# UNITED STATES PATENT AND TRADEMARK OFFICE

APPLICATION NO.	FILING DATE	FIRST NAMED INVENTOR	ATTORNEY DOCKET NO.	CONFIRMATION NO.
10/749,210	12/30/2003	Sang-Do Park	11038-180-999	1859

**Office Action Summary**

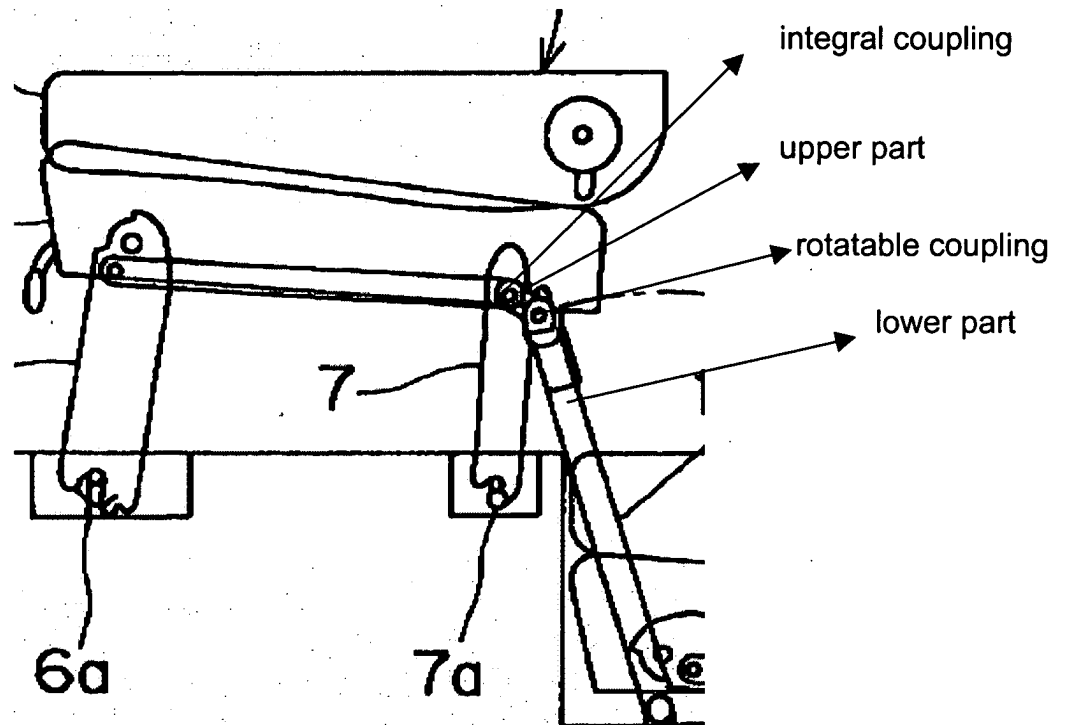
9. Claim 1 is rejected as best understood with the above cited indefiniteness under 35 U.S.C. 102(e) as being anticipated by Sugiura et al. (6,644,730). Sugiura et al. discloses a sinking seat (1) for a vehicle, comprising: a front mounting part (unlabeled) composed of catch legs (6), each catch leg having a catch (unlabeled) encompassing and being coupled to a striker (6a) for supporting the lower side of a cushion (1a); a rear mounting part (unlabeled) having grooved legs (7), each grooved leg having a coupling groove (unlabeled) into which a striker (7a) inserted; and a rear leg (10) integrally coupled to said grooved leg (7) at a pivot point (unlabeled). Said rear leg (10) includes a lower part rotatably coupled to an upper part. See the labeled figure below.
